ADDENDUM NO. 1
Amelia River Waterfront Stabilization Parking Lots C & D
City of Fernandina Beach
Invitation to Bid # 21-06
Issued: May 25, 2021

III. Changes to Drawings: (See attached)

Drawing name: F:\PASSERO\FHB\99000047.0095.FHB.Waterfront\Airport\C5-01-PROF_XSCT.dwg C6-2_XSCT May 25, 2021 5:57am by: EBredestege

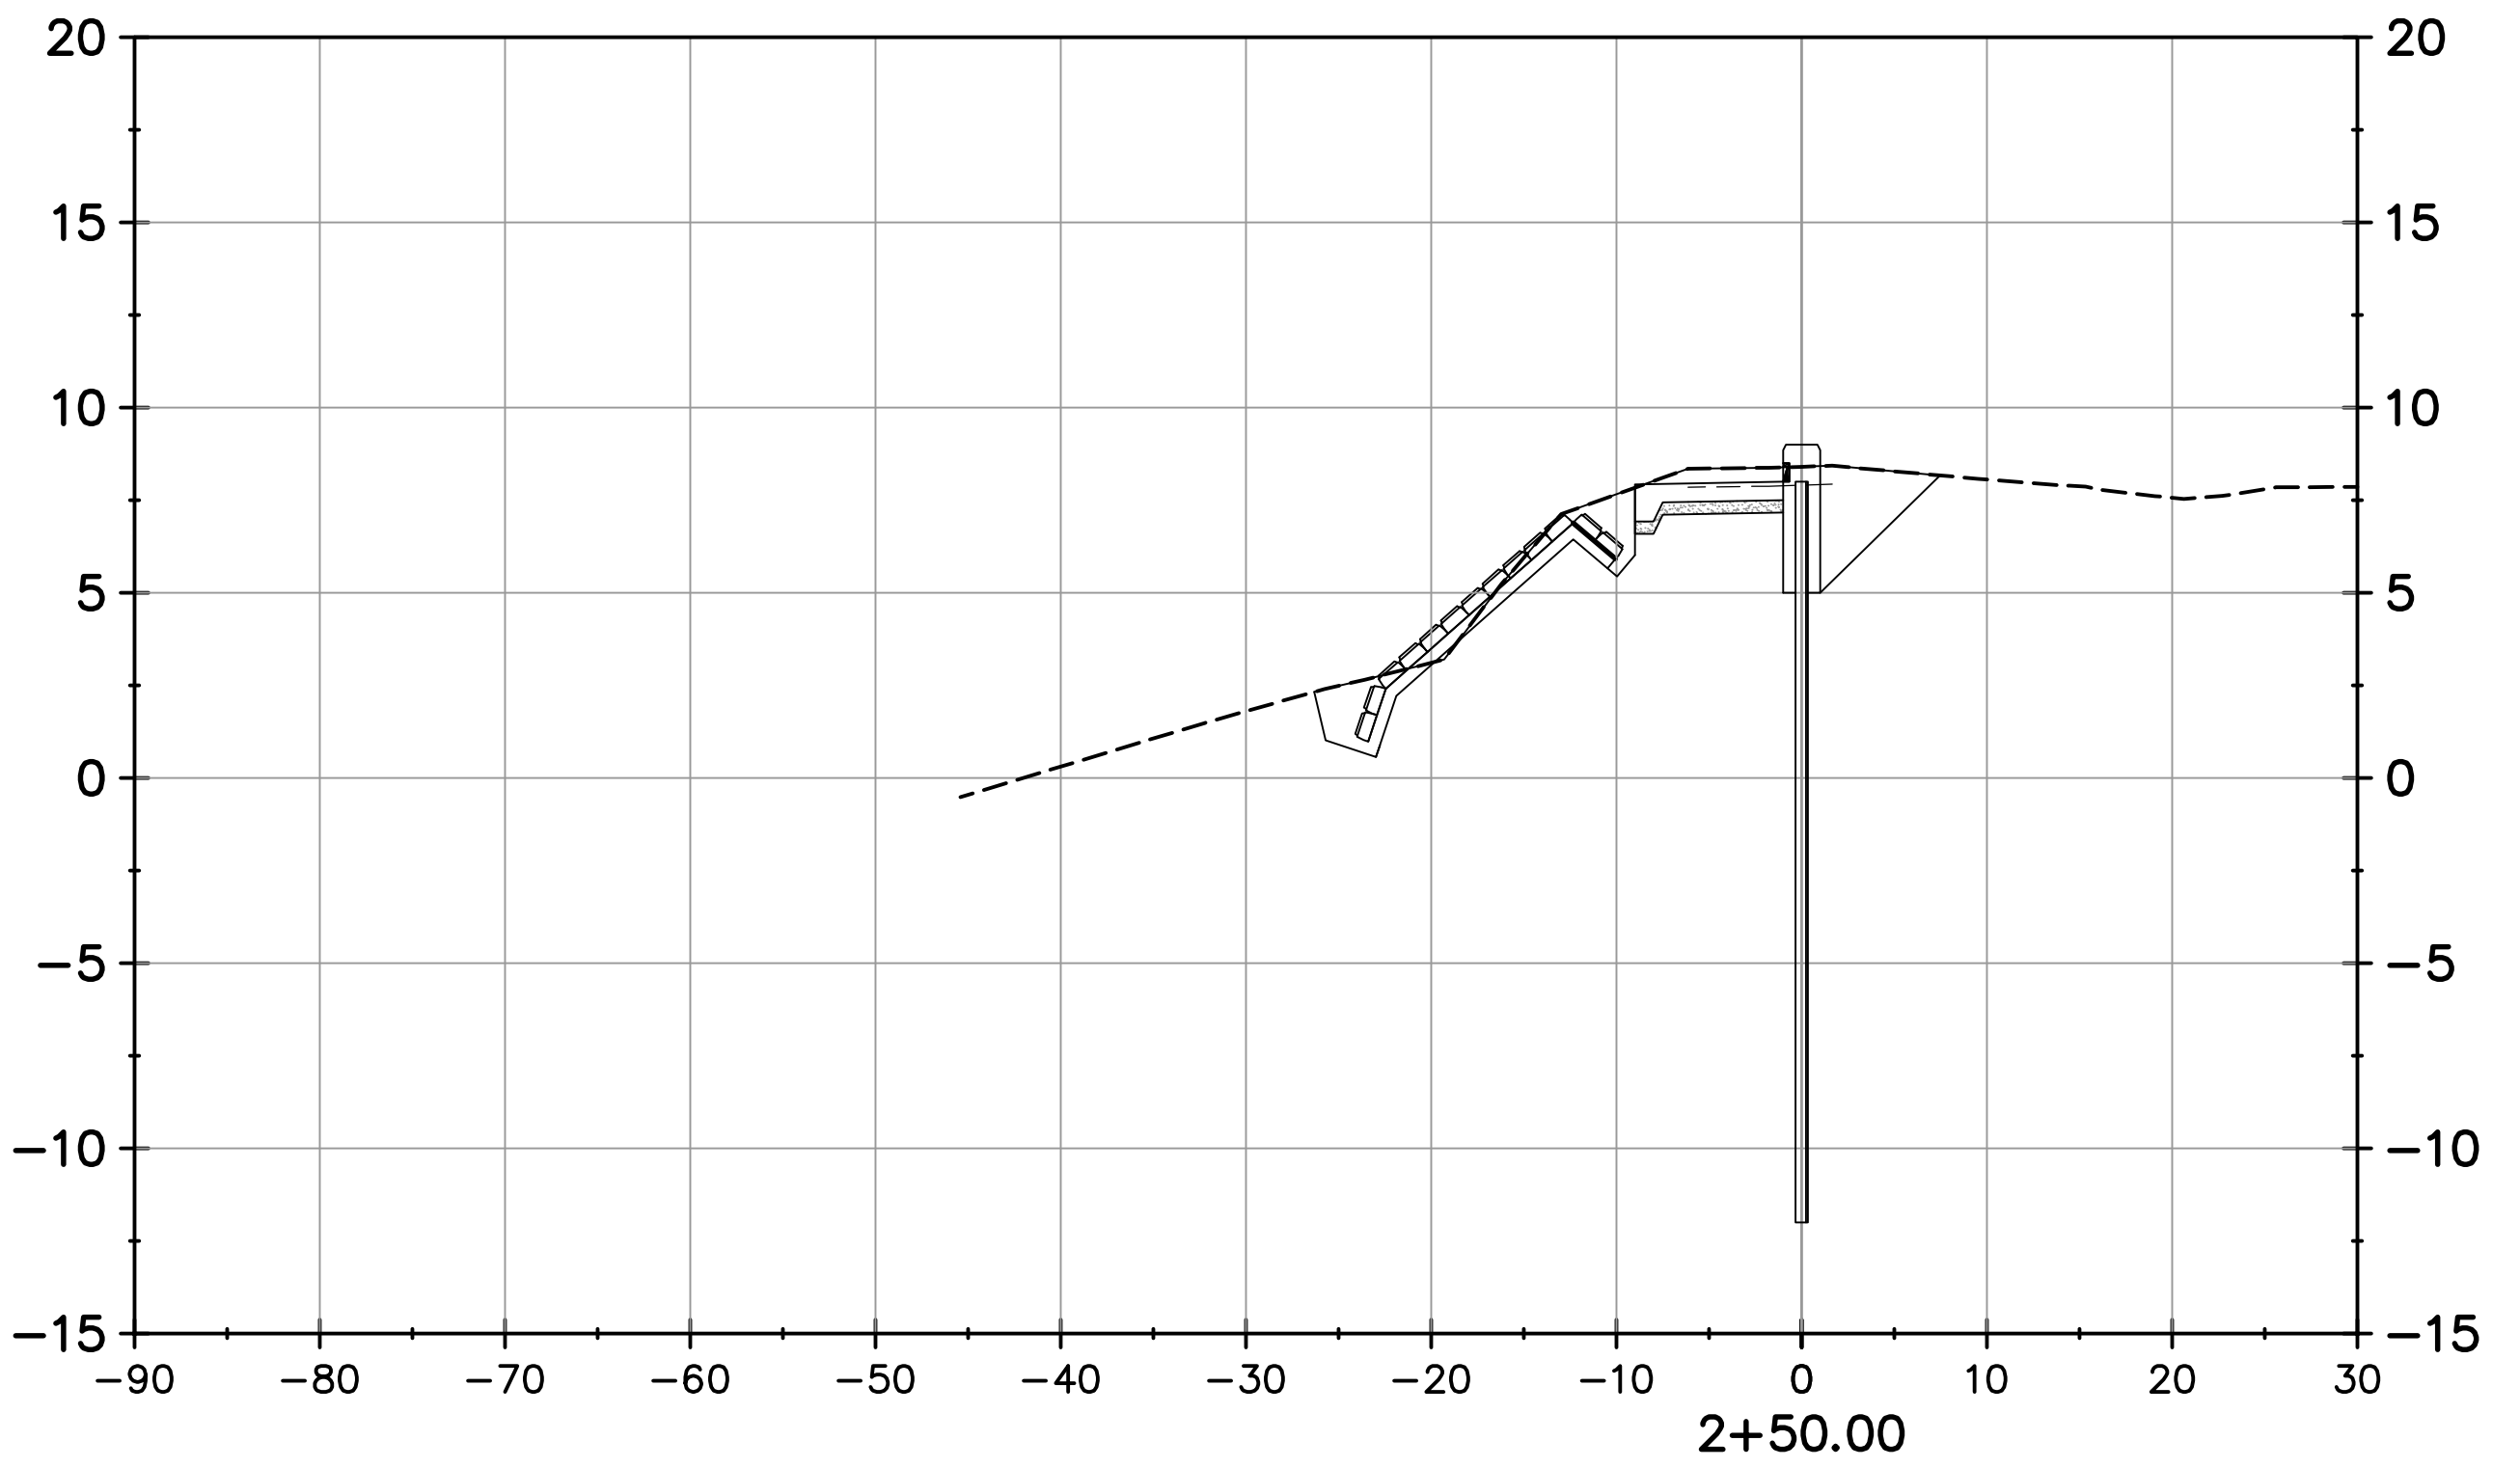
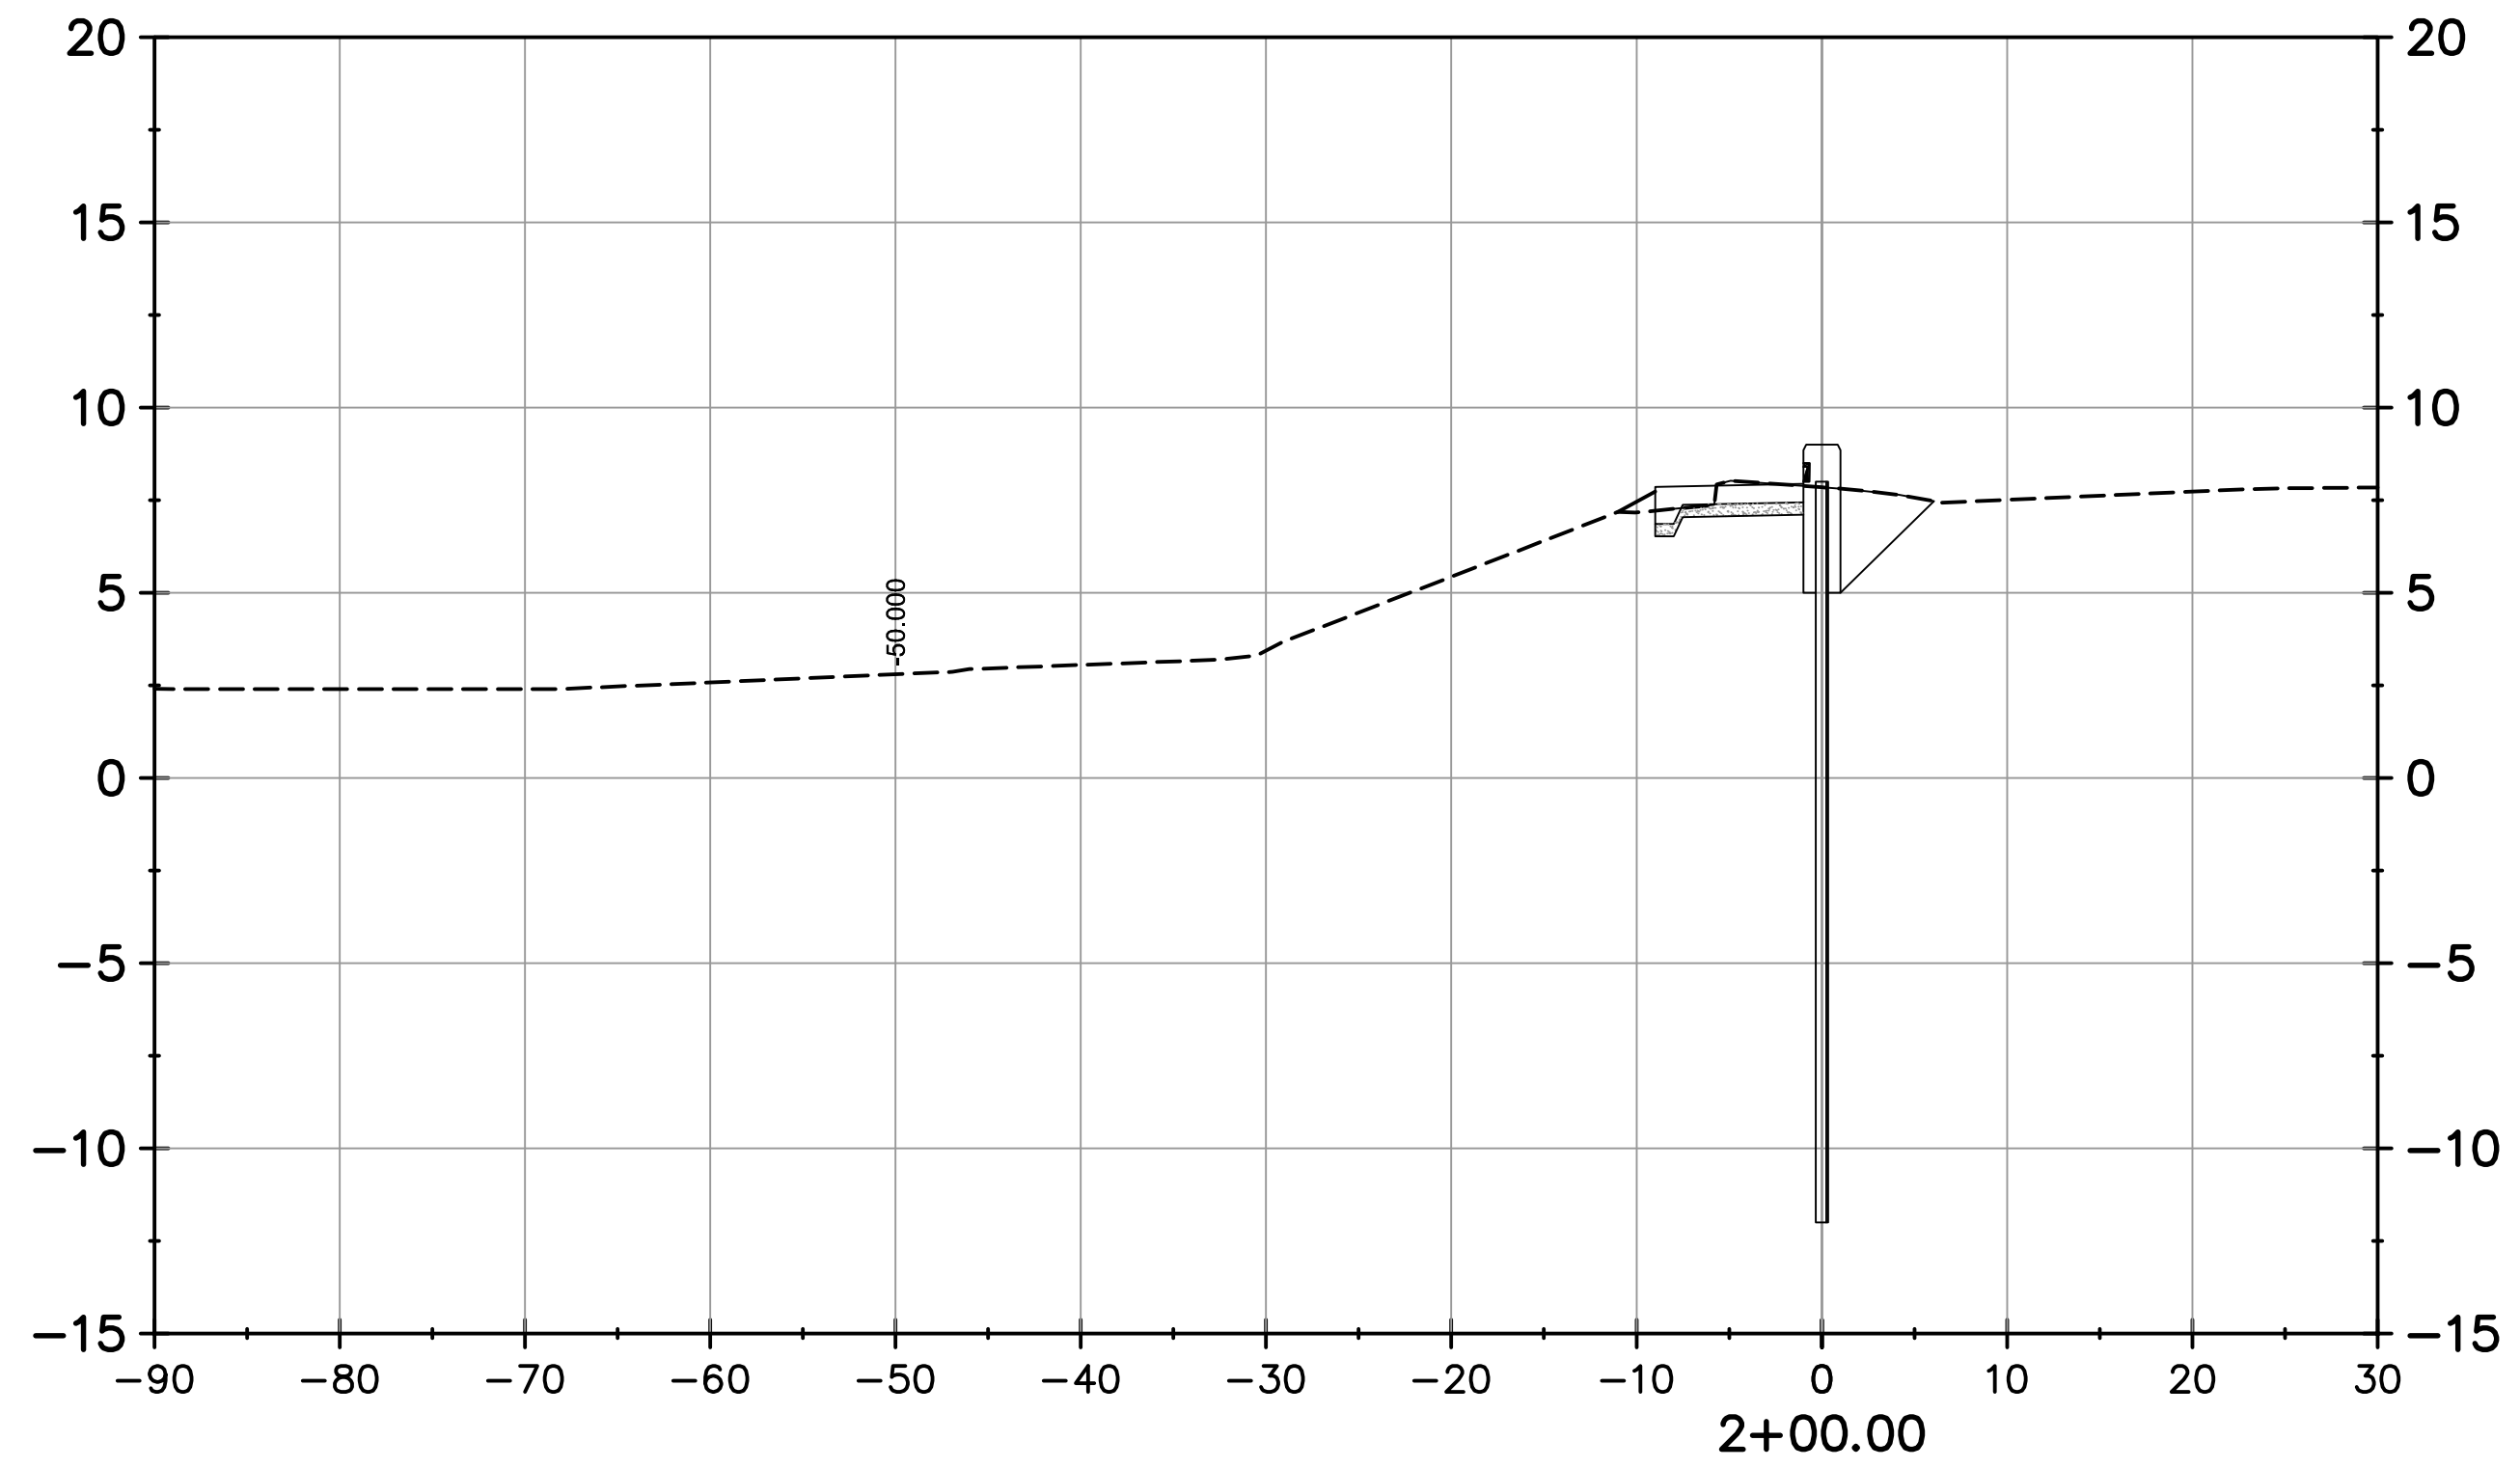
- 20) Sheet C6-1 - Revised I-Wall & Boardwalk Alignment and Cross Sections Adjusted.
- 21) Sheet C6-2 - Revised I-Wall & Boardwalk Alignment and Cross Sections Adjusted.
